AMENDMENT A1 - ALUMINUM POLE DETAILS AND SPECS

CUMBERLAND
POLICE DEPARTMENT
LICENSE PLATE READER
INSTALLATION

SUPPLEMENTAL PERMIT PROVISIONS
Cumberland Police Department
Automated License Plate Reader Cameras
Permit #001385 – Issued 11/22/22
WIS 48 & US 63
City of Cumberland
Barron County

EQUIPMENT AND
FOUNDATION
DETAILS

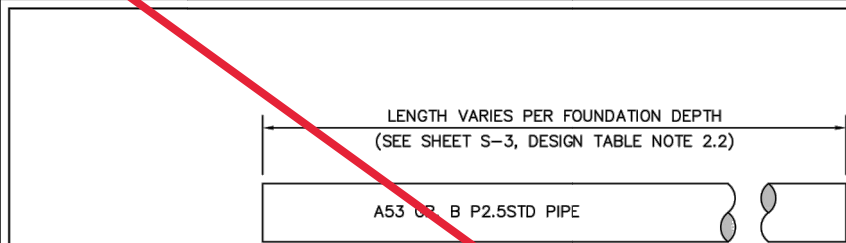
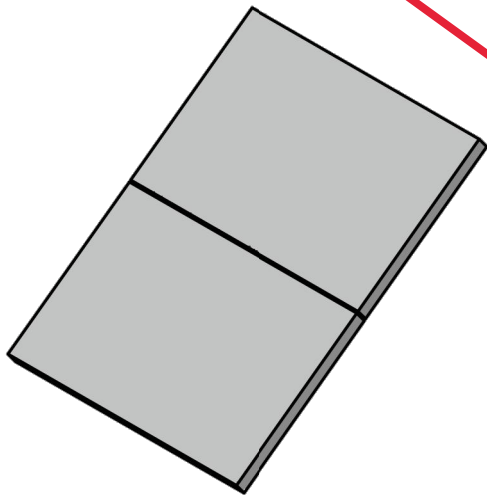
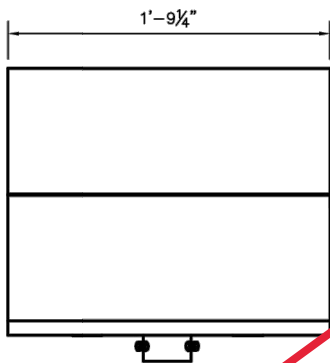
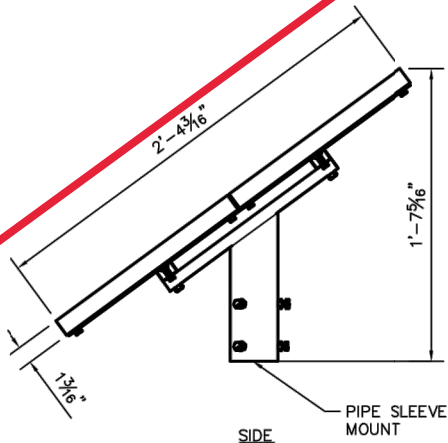
SEE AMENDED SHEETS 1-5 FOR ALUMINUM POLE DETAILS
